## **Technical Bulletin**

TITLE: PELICAN™ REDESIGNS THE 9430 REMOTE AREA LIGHTING SYSTEM (RALS)

PRODUCTS AFFECTED: PELICAN 9430 REMOTE AREA LIGHTING SYSTEM (RALS)

Added more efficient LEDs

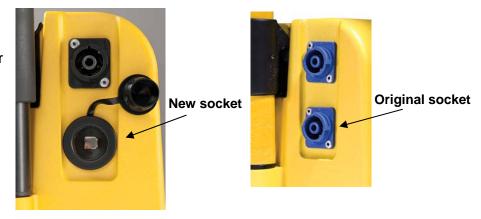
The 9430 RALS has been redesigned with the following improvements:

- New array 6 LEDs
- Same lumen output:
  - o 2,000 in High
  - o 1,000 in Low
- Same run time:
  - o 8 hours in High
  - o 15 hours in Low

Original array - 24 LEDs

- Lumen output:
  - 2,000 in High
    - o 1,000 in Low
- Run time:
  - o 8 hours in High
  - o 15 hours in Low
